Service Bulletin 590

Subject: Re-torque Engine Cover Bolts

Bulletin Number	Models Affected	VIN Range		Markets Affected
590	Speed Triple 1200 RS	From AD2117	AW0999	All

Alternator Cover Tightening Sequence

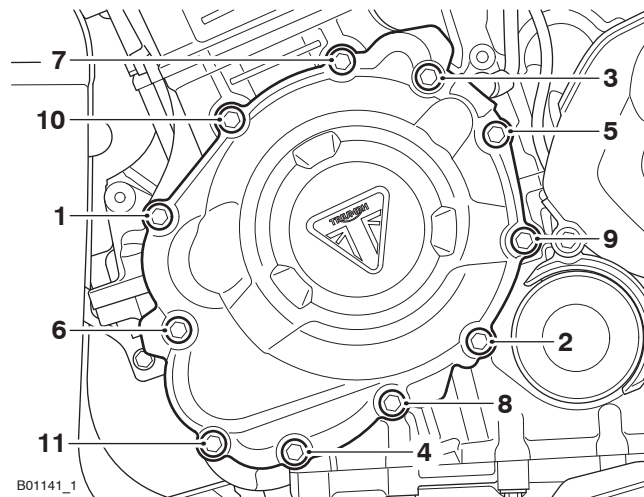
Alternator Cover - Tightening Procedure

1. Tighten fixings one to eleven in the sequence shown to **10 Nm**.
2. Re-tighten fixings one and two to **10 Nm**.

Clutch Cover Fixings Tightening Sequence

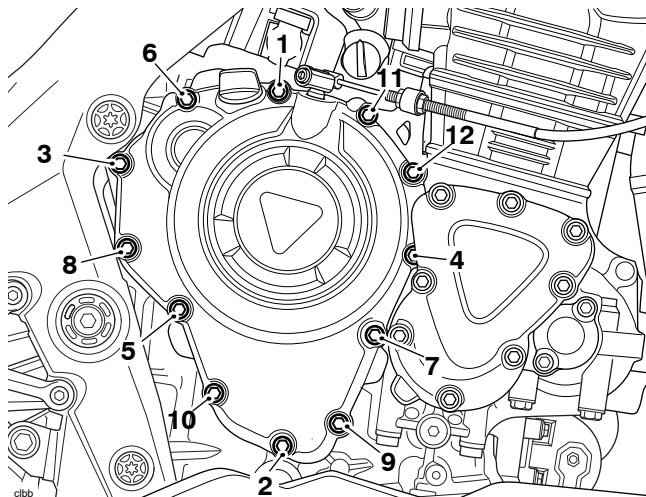
Do not tighten fixing 4 during the tightening procedure.

Attempting to tighten fixing 4 will damage the clutch cover and crankshaft end cover and/or fixing.

1. Tighten fixings one to three in the sequence shown to **10 Nm**.
2. Tighten fixings five to twelve in the sequence shown to **10 Nm**.
3. Re-tighten fixings one and two to **10 Nm**.

Crankshaft End Cover Fixings Tightening Sequence

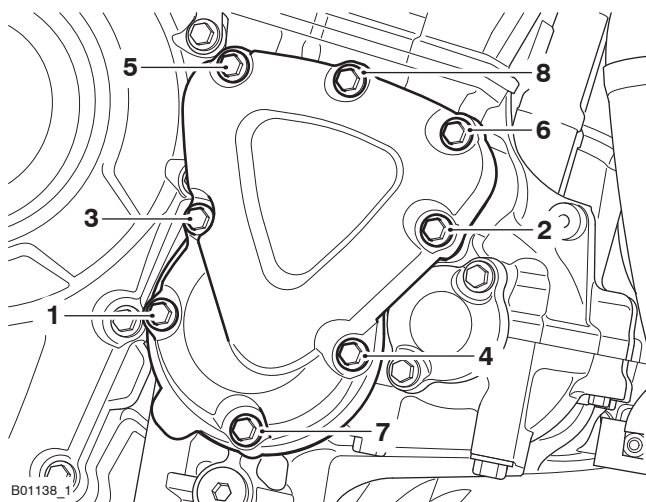
1. Tighten fixings one to eight in the sequence shown to **10 Nm**.
2. Re-tighten fixings one and two to **10 Nm**.

Balancer End Cover - Tightening Procedure

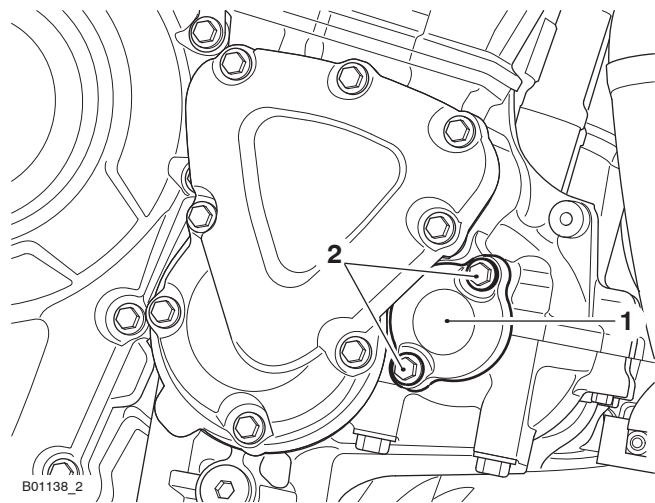
- 1. Tighten both fixings to **10 Nm**.
